CITY PLAN COMMISSION**THURSDAY, OCTOBER 6, 2022****FILE NUMBER:** S212-328**SENIOR PLANNER:** Mohammad H. Bordbar**LOCATION:** Merlin Street, west of Al Lipscomb way.**DATE FILED:** September 7, 2022**ZONING:** PD 363 (Subarea 2)**PD LINK:** <https://dallascityhall.com/departments/city-attorney/Articles/PDF/Article%20363.pdf>**CITY COUNCIL DISTRICT:** 7 **SIZE OF REQUEST:** 1.899.-acres **MAPSCO:** 46N**APPLICANT/OWNER:** Southfair Community Development Corporation, City of Dallas

REQUEST: An application to replat a 1.899-acre tract of land containing all of Lots 18 through 28 in City Block 7/854 to create 11 lots ranging in size from 5,225 square feet to 15,557 square feet and to dedicate a right-of-way on property located on Merlin Street, west of Al Lipscomb way.

MALCOLM'S POINT ADDITION
LOTS 1-24
1.00 ACRES
11.989 ACRES
JOHN GROSBEY SURVEY, ABSTRACT NO. 495
CITY OF DALLAS, DALLAS COUNTY, TEXAS
DALLAS, TEXAS 75201

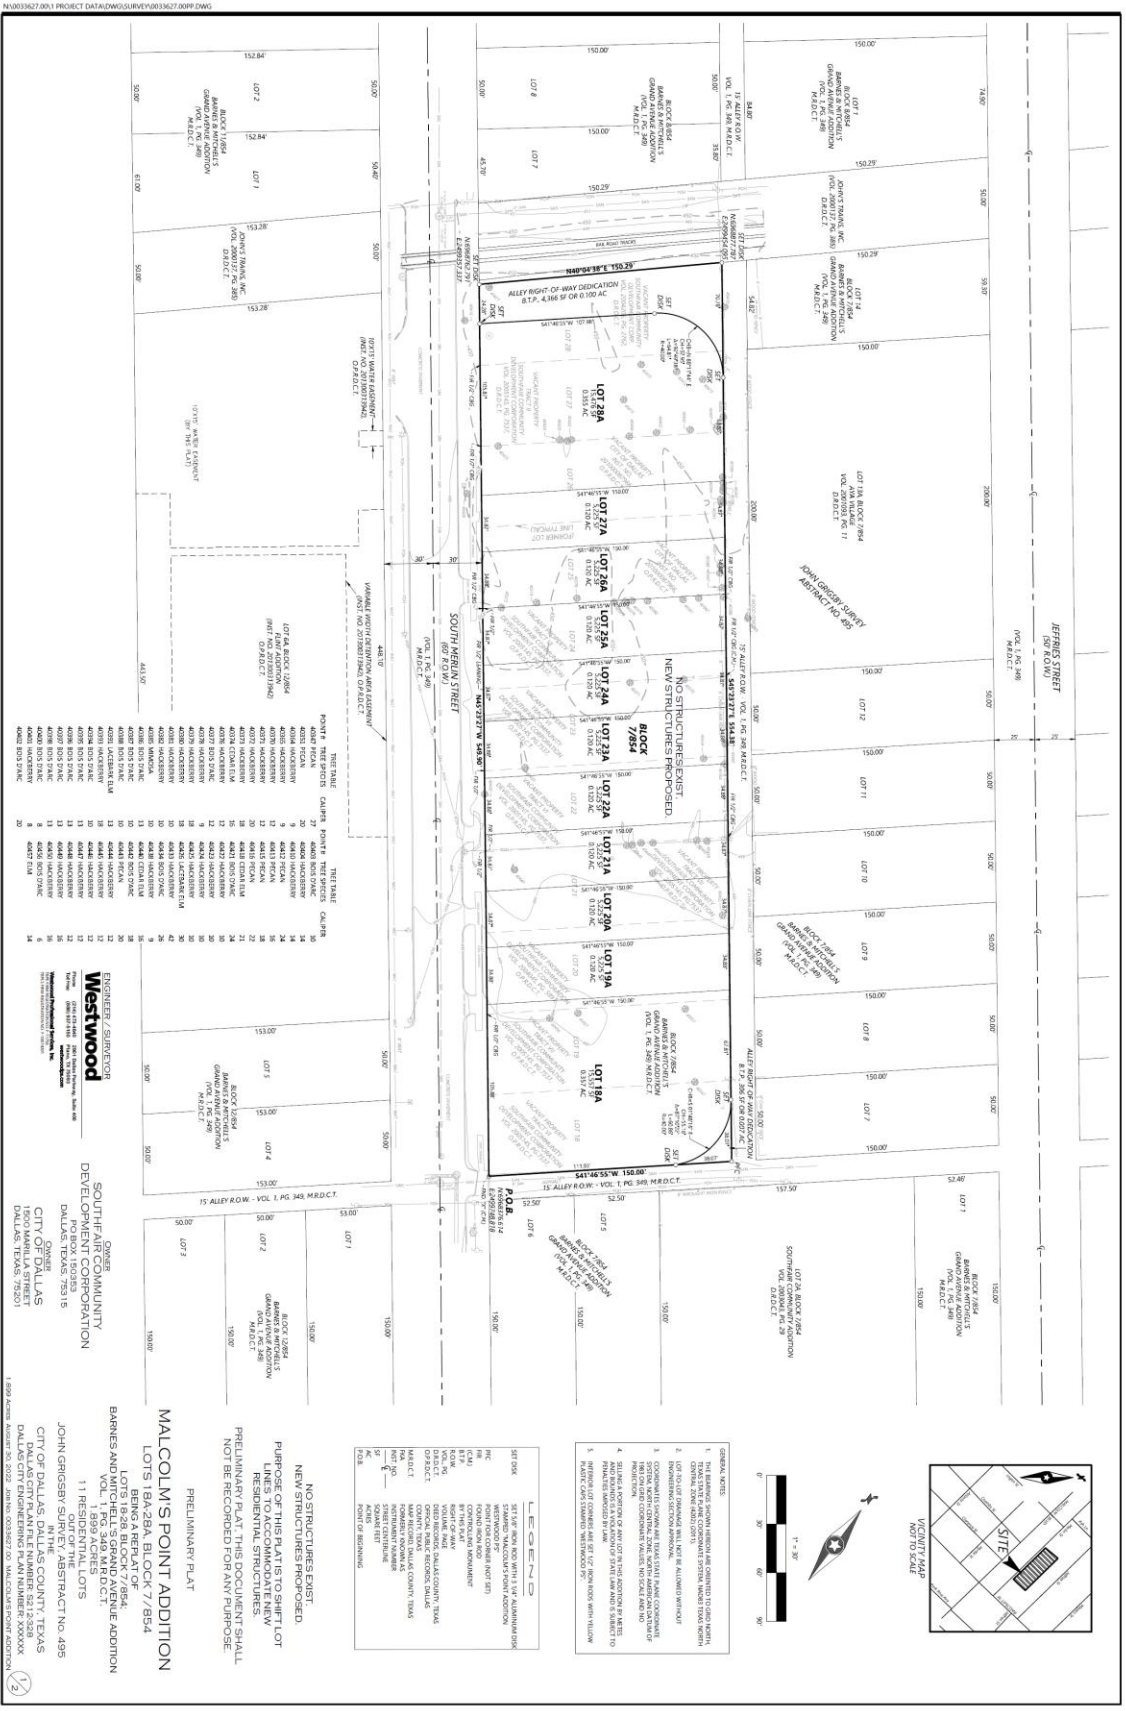
16. On the final plat, dedicate a 15-foot by 15-foot Alley Sight Easement at the intersection of Merlin Street & the alley. *Section 51A-8.602(e)*

17. On the final plat, include a note that the site is within the 65 LDN contour of Dallas Love Field and this noise level may require special construction standards for certain uses per the building code. Dallas Building Code, Section 425.
18. Provide minimum alley ROW at the alley bend per City of Dallas Standard Construction Details File 251D-1 Page 4002

19. Prior to final plat, submit a completed final plat checklist and all supporting documents.
20. On the final plat, chose a new or different addition name. Platting Guidelines.

22. On the final plat, change “South Merlin Street” to “Merlin Street”. Section 51A-8.403(a)(1)(A)(xii)
23. On the final plat, identify the property as Lots 18A, 20A-B, 21A, 22A, 23A-B, 24A, 25A-25B, 26A in City Block 7/854. Ordinance 1A, Page 131 pages 131-148, Section 2 (passed August 13, 1872).
